Flood Risk Assessment and SuDS Statement

**Hillcrest and Tussocks
The Causeway
Therfield**

Response to LLFA comments dated 05/11/2024

- 3.1 A consultation response was received from the LLFA, dated 05/11/2024. Please find below the response to these comments, with the comments shown in grey italics and EAS responses in blue text.

Appendix I – Proposed SuDS Layout

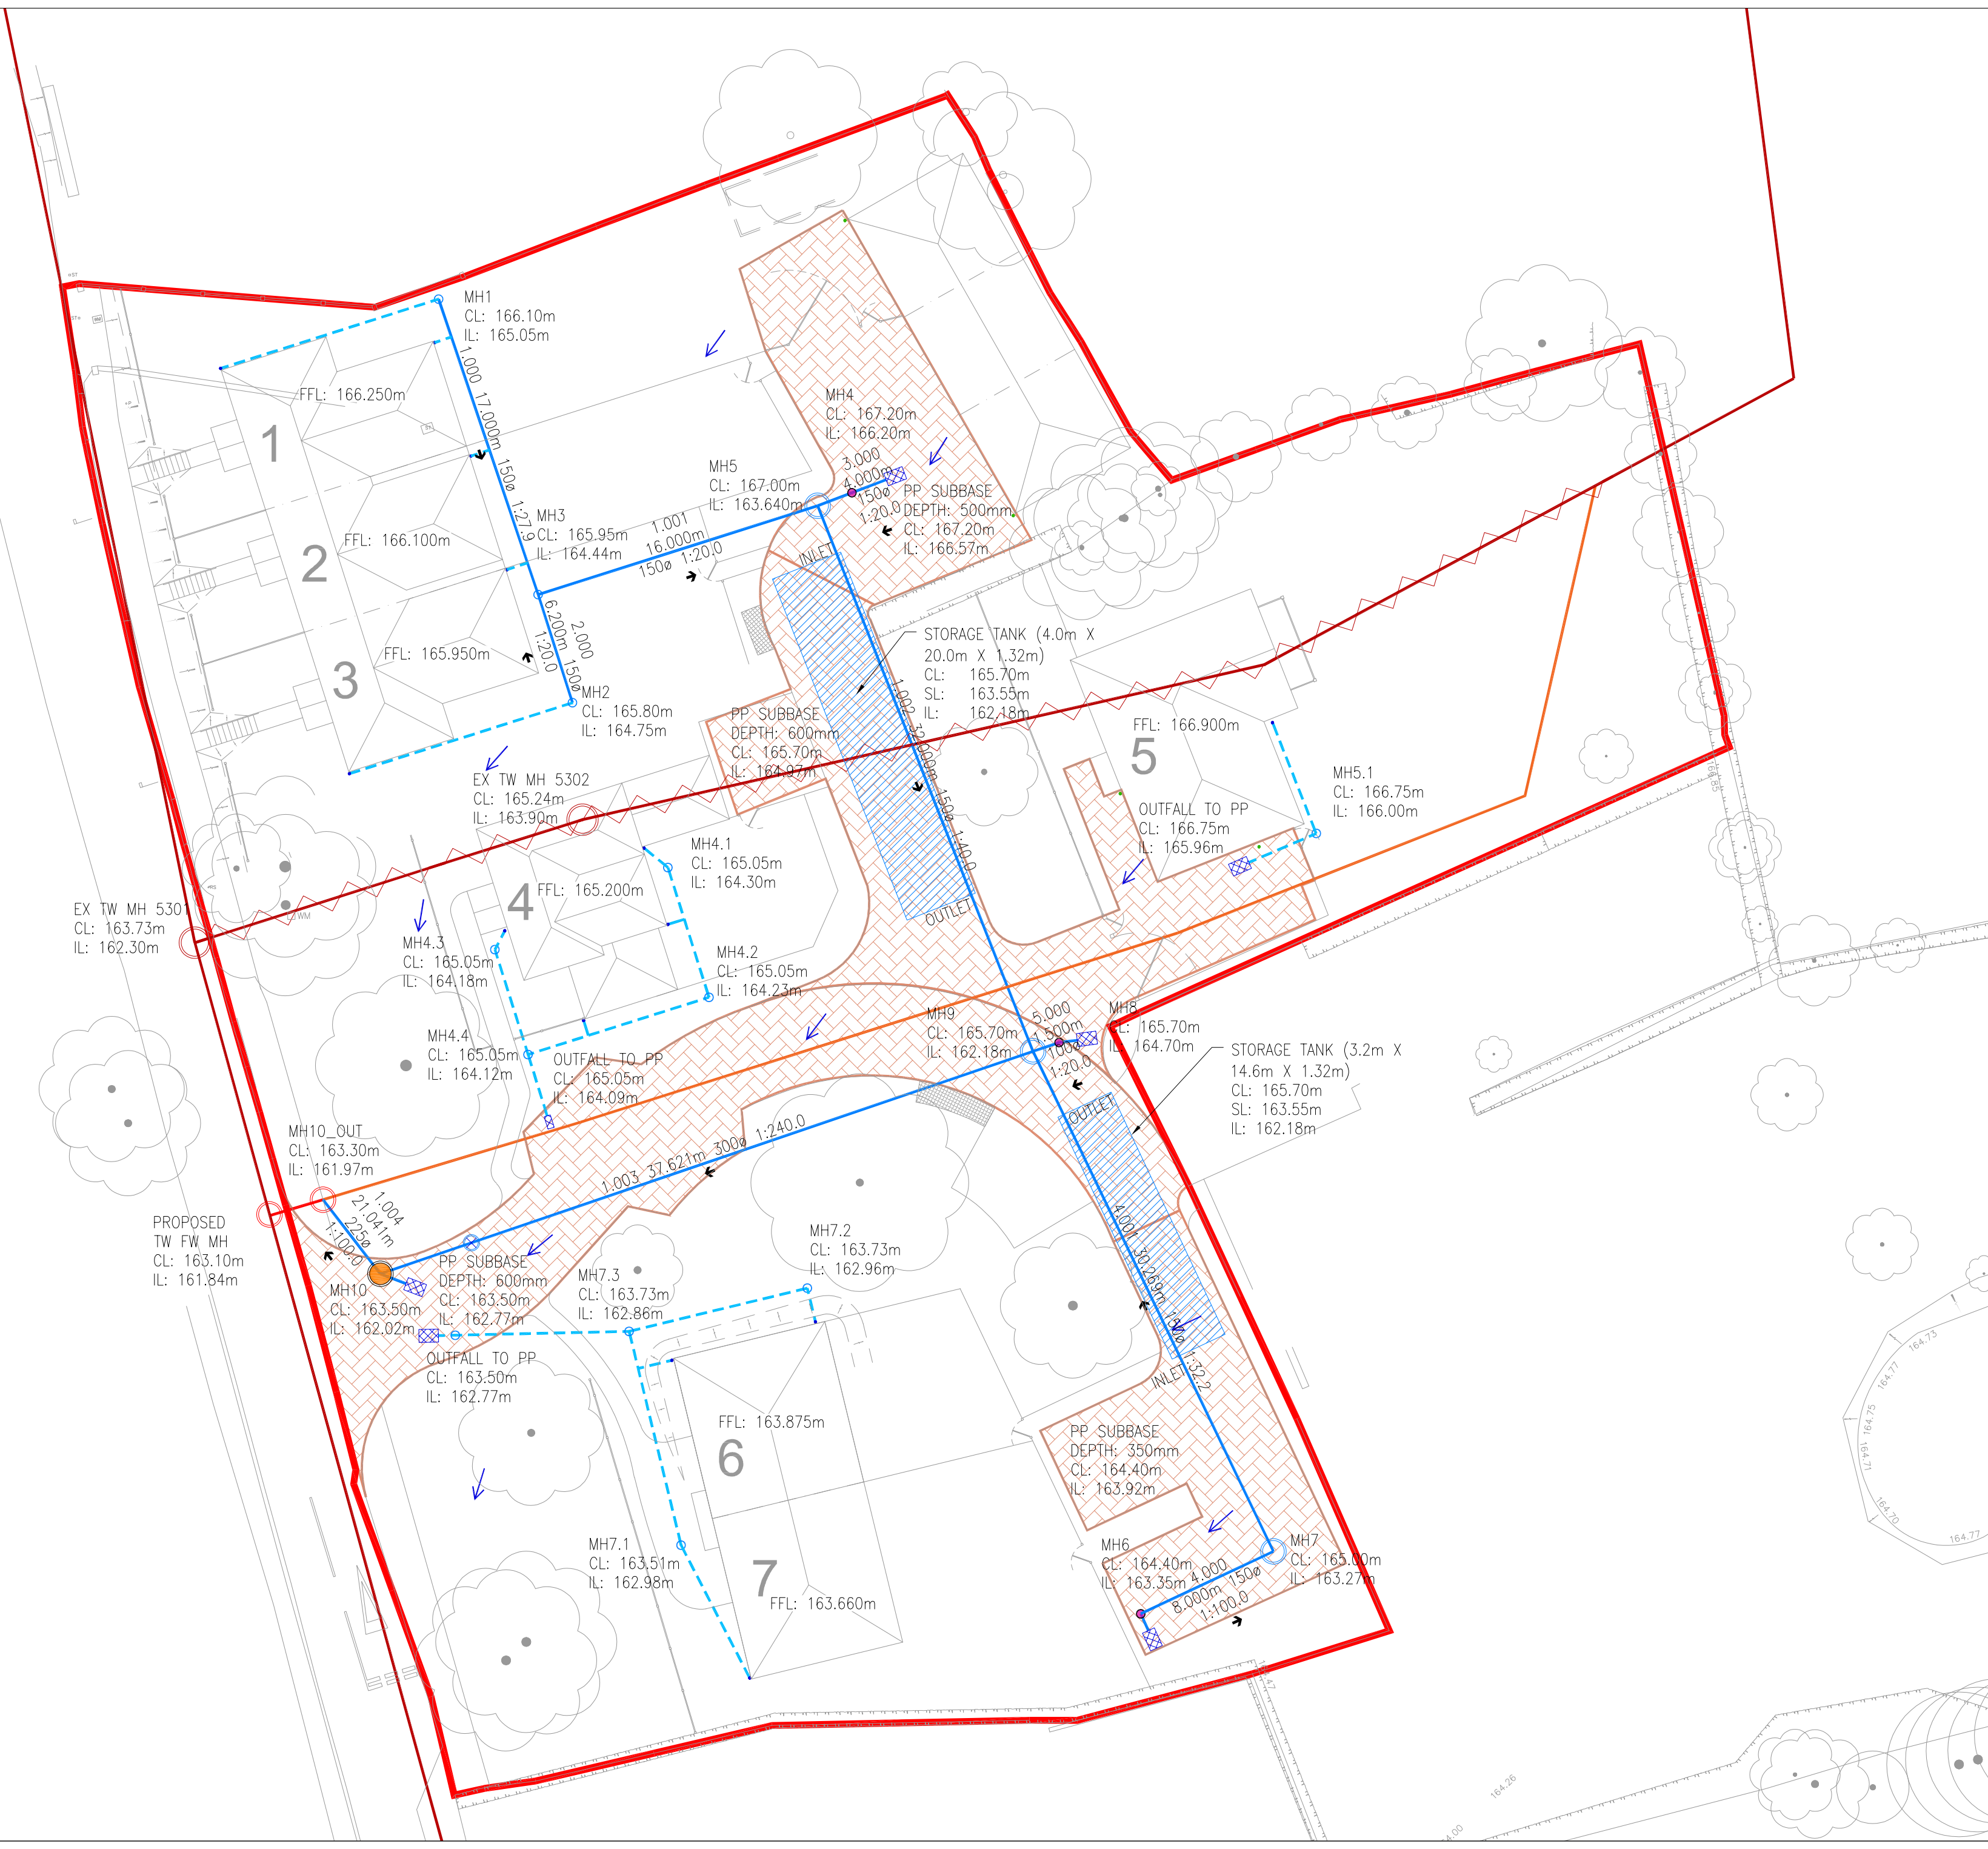
5. Clarifications on the design of the drainage network shown on the Surface Water Drainage Strategy Drawing (DRD1).

b. Why are there two MH1's on the drawing? The one to the north of the site, and one in a central location near the southern storage tank.

h. The LLFA notes that there is a large area on the Surface Water Drainage Strategy Drawing (DR01) (14.06.2024) that is allocated as permeable paving, however, on the Outline Landscape Proposals drawing (PR271-01) (22.10.2024) this is now proposed as macadam and asphalt surfacing. The applicant is required to provide clarification as to the final surface material as this will have an impact on the drainage strategy and layout.

7. Further information on any exceedance flooding, flow paths and ponding areas. The applicant is required to submit a drawing which demonstrates any exceedance flooding from the drainage network. This will need to include the areas in which flood waters will be stored, the depth of any flood water and any exceedance flow arrows. This drawing will also need to include the finished floor levels and finished ground levels.

3.14 Cover, Soffit and Invert levels are provided on the SuDS layout drawing in **Appendix I**.

3.15 Attenuation storage tanks are to be connected via the piped network. Inlet and Outlet location are marked on the SuDS layout drawing in **Appendix I**.

3.23 Minor pipework has been added to the drawing in **Appendix I**.

3.31 Exceedance flow routes are shown with the drainage strategy in **Appendix I** of the updated FRA. A separate drawing is also included in **Appendix M** to ensure clarity.
